**THE METROPOLITAN
COMPANIES, INC.**

2203 & 2209 eastlake avenue e
seattle, wa 98102

early design guidance
DPD project #3016024

23 july 2014 EDG meeting 2

SECTION 4 | exceptional tree on site- japanese maple

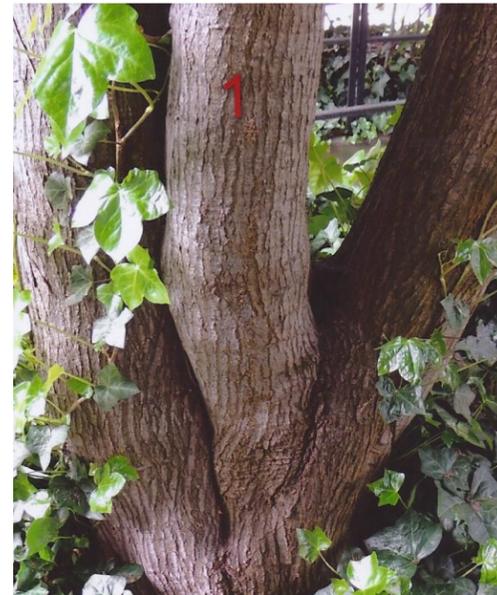
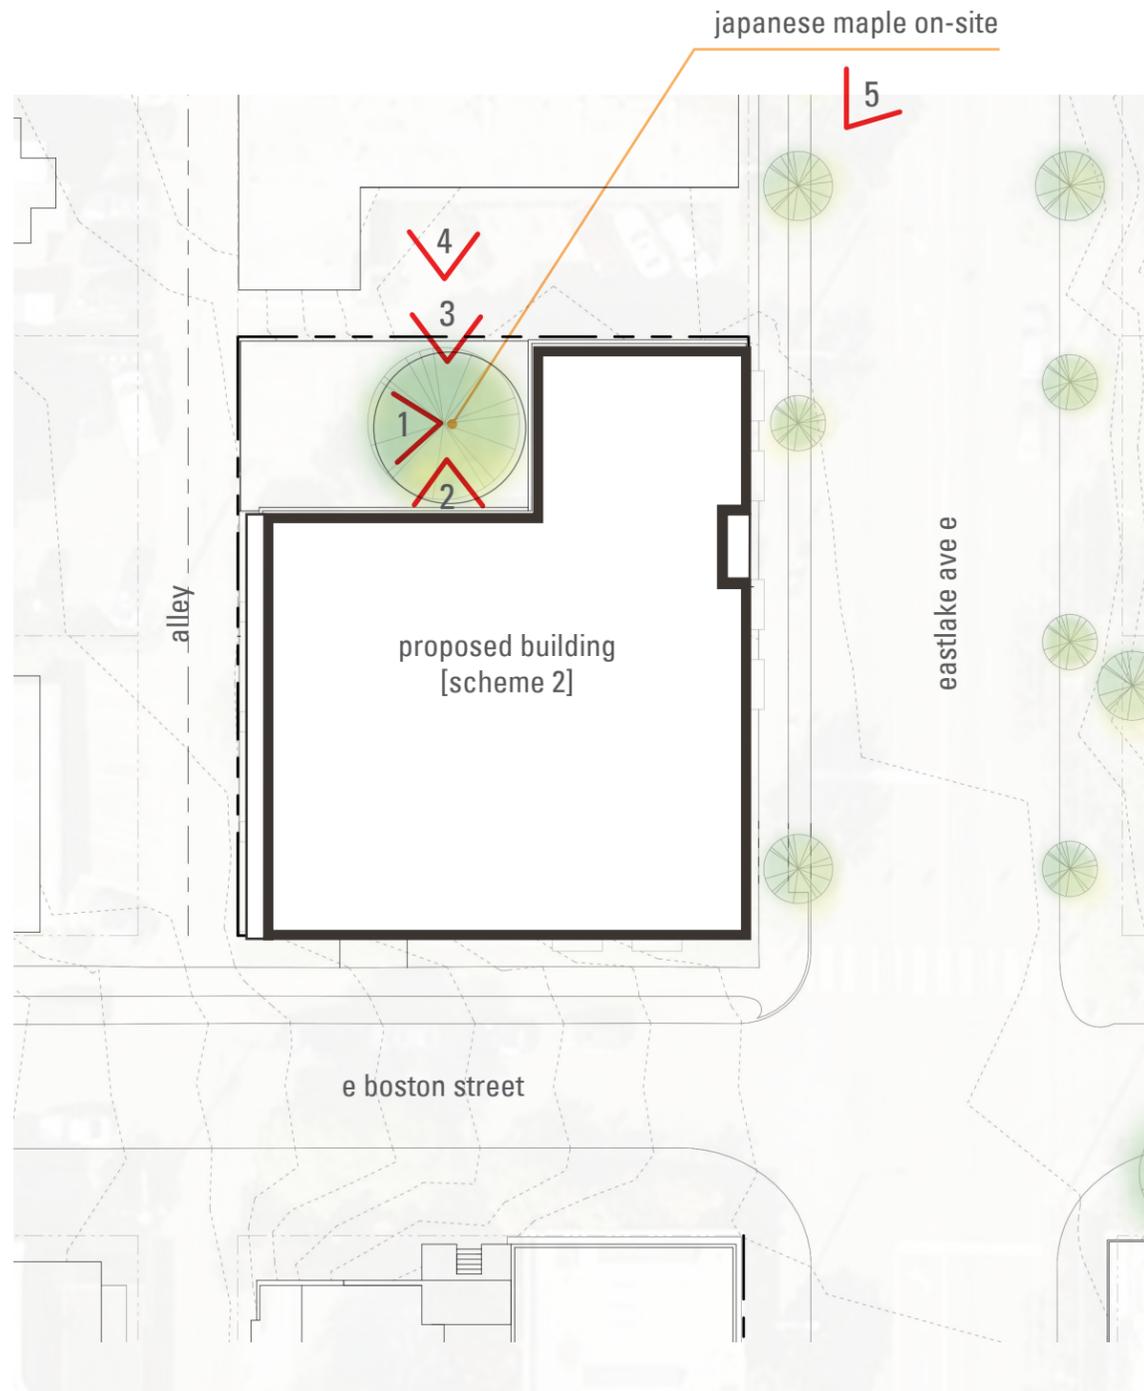
What follows is a brief discussion on options for the tree and its condition. The trees main trunk sprouts from the ground in 3 tightly bound stems (photo#1) then splitting in 4 scaffolding branch with further branching from there. The crown of the tree has good color and appears to be defect free (photo #4). The issues with this tree are the three stems forming the main trunk, a canopy largely off center/leaning from the trunk with 75% of this on the west side of the trunk (photo#3) and a small volume of soil to grow in (Photo #2). The tree is surrounded by a concrete flower bed thus creating a limited area for support and further root spread. Due to the size of the tree in my opinion the tree outdates the cement surround. Either the planter was rebuild or the tree survived root cutting from when the concrete was formed.

Addressing the trunk formation, the three stems in this position typically will result in the decline and eventual death of this tree. What occurs is that as the 3 pieces grow larger the cambium tissue becomes compressed on the sides of the stem growing in the middle killing the cambium and the inside areas of the remaining stems that are in contact with the middle stem. This compression is having little effect at this time. It none the less will have devastating effects in the future with no corrective measures possible.

There is limited space for this tree to grow this is caused by a raised cement flower bed. In normal conditions the root system would spread out with structural and feeder roots as far as the edges of the tree canopy. As can be seen in the photos the normal root plate is spread less than a third of the space required for normal stable growth.

My professional opinion is that this tree will be problematic to move and may need to be best replaced outright. At best one could dig this tree, tie up the canopy to reduce its area somewhat which is 30' circumference (Photo #4) and possible store it in the neighboring parking lot for replanting upon

SECTION 6 | 1st EDG response - massing

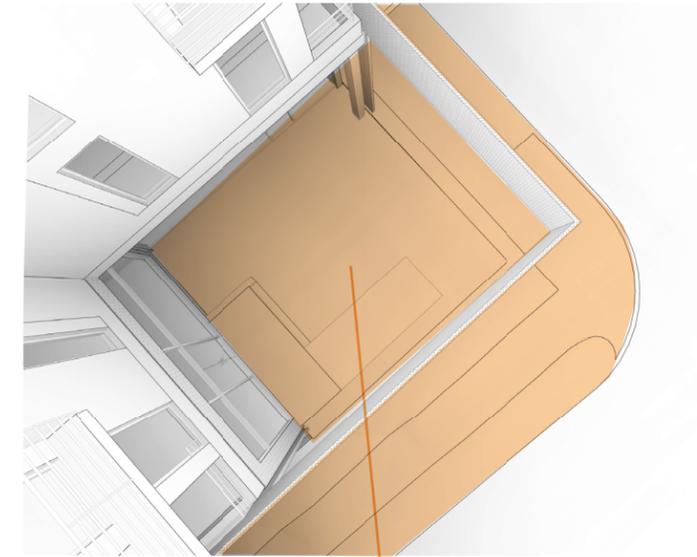
1. MASSING. The Board felt Massing Option 3 should move forward to MUP submittal with the following guidance:
 - The Board preferred Massing Option 3 which locates the central entry courtyard at the corner of Eastlake Avenue E and Boston Street. The Board agreed the corner courtyard promotes pedestrian activity, provides a gateway to the community, and sets a precedent for a more open intersection (CS2-C, PL1-A2, PL3-A2). *In response to EDG, the proposal has been further developed to incorporate the open courtyard at the southeast corner of the building.*

- The Board noted Massing Option 3 was preferable with commercial uses on each street and live work uses wrapping onto the alley. At the Recommendation Meeting, the Board requested vignettes of each façade to show how the commercial spaces relate to the pedestrian experience (CS2-B2, PL3-B3). *In response to EDG, the proposal has been further developed and incorporates commercial space on the Eastlake Ave E frontage, south facade of the courtyard, with live/work unit wrapping the corner of Boston to the alley.*

trellis enclosing courtyard while maintain open intersection

courtyard and pedestrian right of way from resident balcony overhead

eastlake commercial use wrapping into the courtyard

live/work use wrapping the corner of boston and the alley

SECTION 6 | 1st EDG response - eastlake avenue

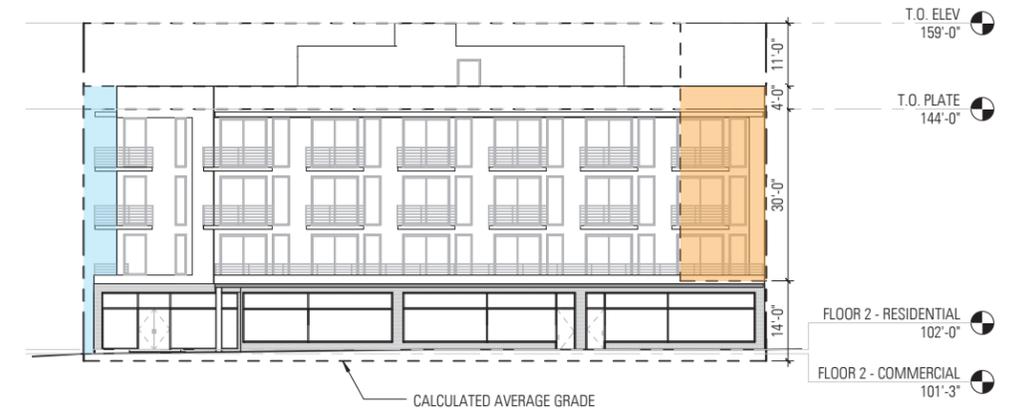
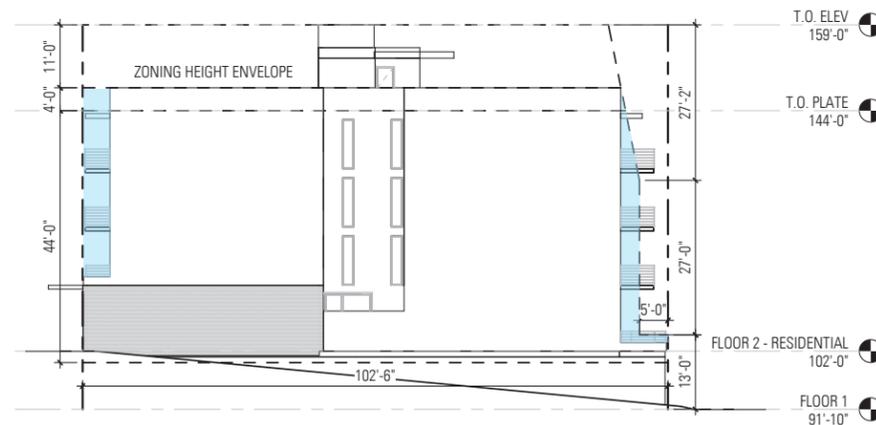
- EASTLAKE AVENUE. The preferred massing proposal includes commercial space at ground level with residential units above.
 - The Board provided guidance to maintain a strong street wall along Eastlake Ave E to the north property line in the area of the required setback (CS3-A).
The Eastlake Ave E street wall is maintained in the proposal through the pedestrian scale, commercial use at the street level, with a setback above, and balconies projecting out to the plane of the building base below.

- The Board also noted they were amenable to additional departure requests along the north setback. The Board felt the structure adjacent to Eastlake Avenue E should be located adjacent to the north property line. The Board provided guidance that further reduction in the north setback should facilitate a generous south setback to provide a larger courtyard space and landscape buffer along the south street property line (CS2).
The proposal establishes an infill condition at the north property line. The maximum allowable FAR is maintained, while providing setbacks on east, south, and west facades. The south facade is pushed 2' north of the street right of way to provide an a wider landscape area that terraces down Boston Street.

- The Board encouraged the applicant to consider an optional second EDG meeting to resolve any proposed changes to the massing location along the north and south property lines (CS2).
North and south property line relationship to building mass, as described herein.

- The Board provided guidance stating the ground level street façade must maintain a strong street edge, but that the upper levels should be setback. The Board felt the provided setback should provide relief from the large façade on Eastlake Ave E. The Board did not state a setback requirement but thought an investigation of successful upper level setbacks in the neighborhood could inform an appropriate setback (CS2-D4 and D5).
Setbacks have been explored, and the proposal reflects this research.

- The Board felt the applicant should investigate use of the setback as a private amenity feature for residents (CS2-B).
Setback as proposed includes a private amenity feature for residents.

- Additional Building Setback Provided
- Reduced Building Setback Requested

SECTION 6 | 1st EDG response - entry courtyard

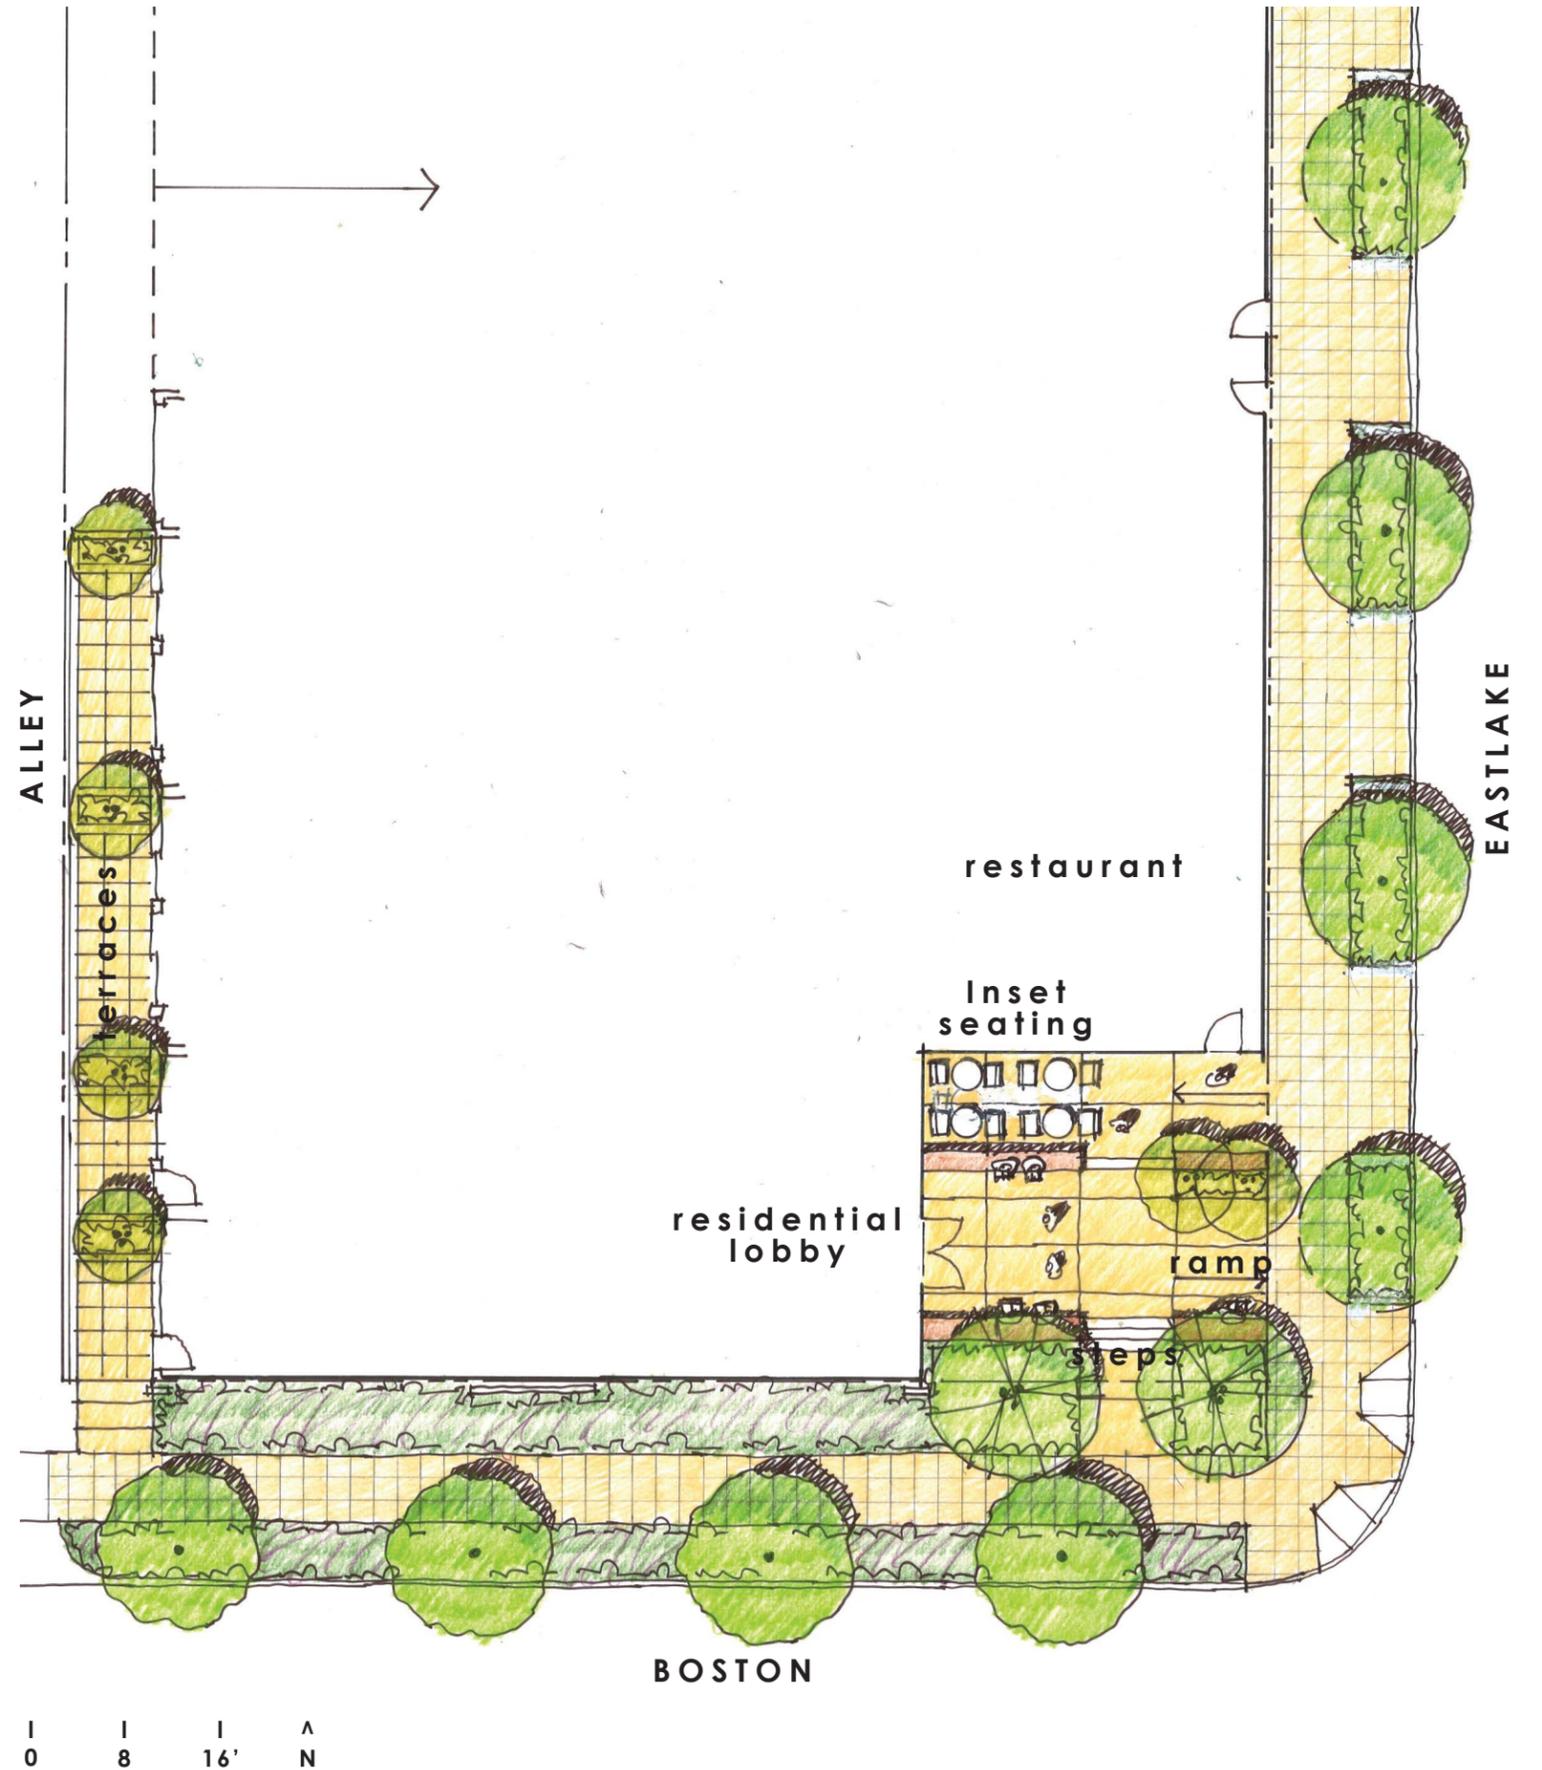
3. ENTRY COURTYARD. The preferred massing option locates a common entry courtyard at the corner intersection.
 - The Board felt the courtyard provides the opportunity for the building to transition from the commercial Eastlake façade to the quieter more residential Boston street. At the Recommendation Meeting, the Board requested information on the design of the courtyard to create a quality open space activated by spillover of commercial uses and resident's path of travel (PL1, PL3).
The courtyard has been further developed to create a quality open space, with activation occurring via the south facing commercial space and operable doors, and the residential entry and lobby. The area integrates building and landscape/hardscape areas together and is intended as a graceful progression of public to private space.

- The Board noted the applicant should study existing neighborhood developments such as the Chloe and Eastlake lofts for examples of successful activation of space (PL3).
Numerous local and areawide spaces have been analyzed and are reflected in the proposed design. See following page for select courtyard analysis.

SECTION 6 | 1st EDG response - boston street

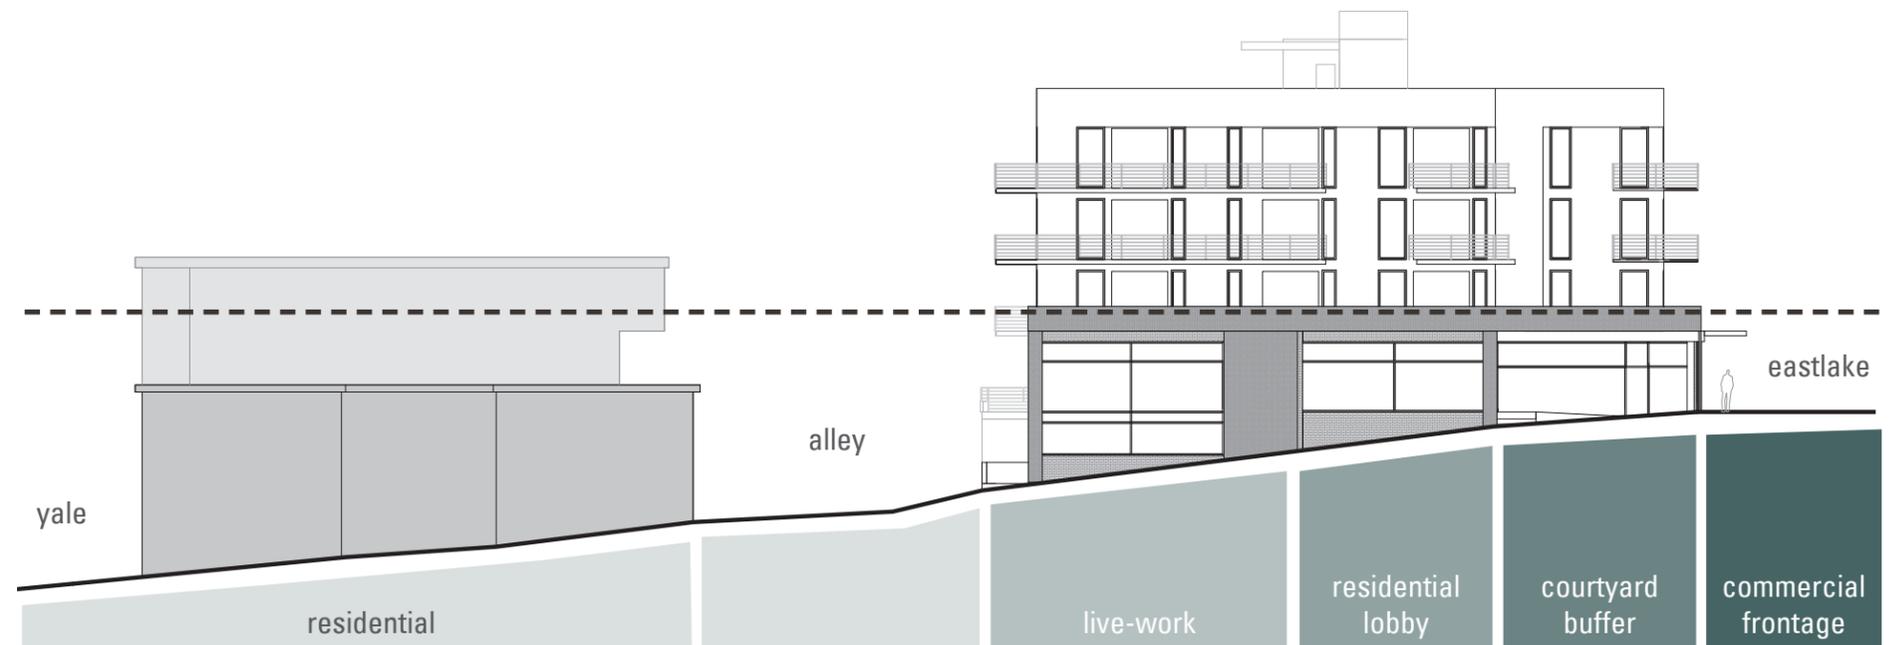
- 4. BOSTON STREET. The preferred massing option locates live work units at the ground level with residential units above.
 - The Board noted the south façade needed a more successful transition to the residential neighborhood. The Board felt this transition could be achieved in a variety of ways, but felt the applicant should investigate an upper level setback above the live work units. Board provided an example of a two story live work base with a setback above as potential solution (CS2-D).
The upper level setback suggested by the DRB during the EDG has been further developed and is reflected in the current proposal. This upper level setback above the Live/Work Unit provides for a transition to the residential zoning to the west.

- The Board noted the live work entry off Boston was important to break the up the ground level massing while providing additional opportunities to incorporate landscaping. At the Recommendation Meeting, the Board requested vignettes of the pedestrian experience and the live work entry treatment (PL3-B).
In response to EDG, the proposed live/work unit turns the corner in order to provide a succesful transition between the commercial use of Eastlake, the slope and zoning of Boston, and the residential zoning and character of the alley. Due to the challenges of the existing sidewalk slope on Boston, the proposal includes expansive windows into the Live/Work unit, with sidewalk access fronting Boston, and the door opening located near Boston, on the west facade.

use of 2 distinct material expressions and lush vegetation near the sidewalk to break down massing of building as shown in this neighborhood building.

setting back the upper levels to break down massing, as shown at the Eastlake lofts.

the building program at E Boston Street transitions from active public uses to residential use to ease the transition

SECTION 6 | EDG 1 response - roof

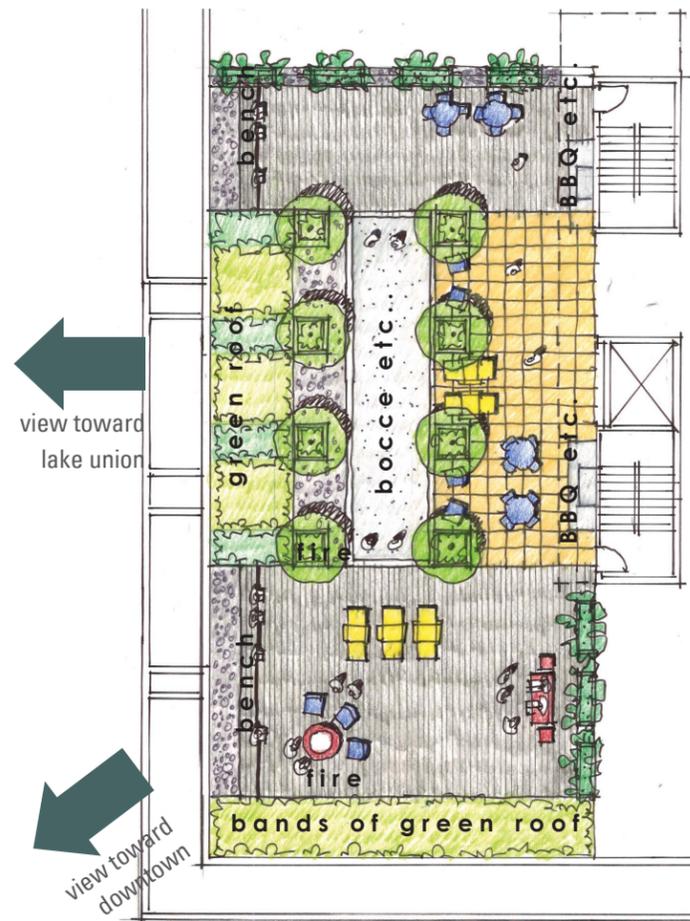
- 5. ROOF: The Board noted the overall grade transition down to Lake Union will provide views onto the roof surface.
 - The Board felt the roof should be developed as a 5th façade. The Board noted that the addition of the green roof would help add visual interest to the roof plane (CS2)
Roof penthouse enclosure and landscape design concept has been developed further, and responds with a clear composition that supports resident use of this exceptional open space opportunity.
 - At Recommendation, the Board would like to see additional detail on the development of the roof as a common amenity space maximizing the existing views to the lake (CS2-B).
Additional plan concepts are provided herein.

planters

funky fire pit

BBQ, etc.

conversation and views

bands of green
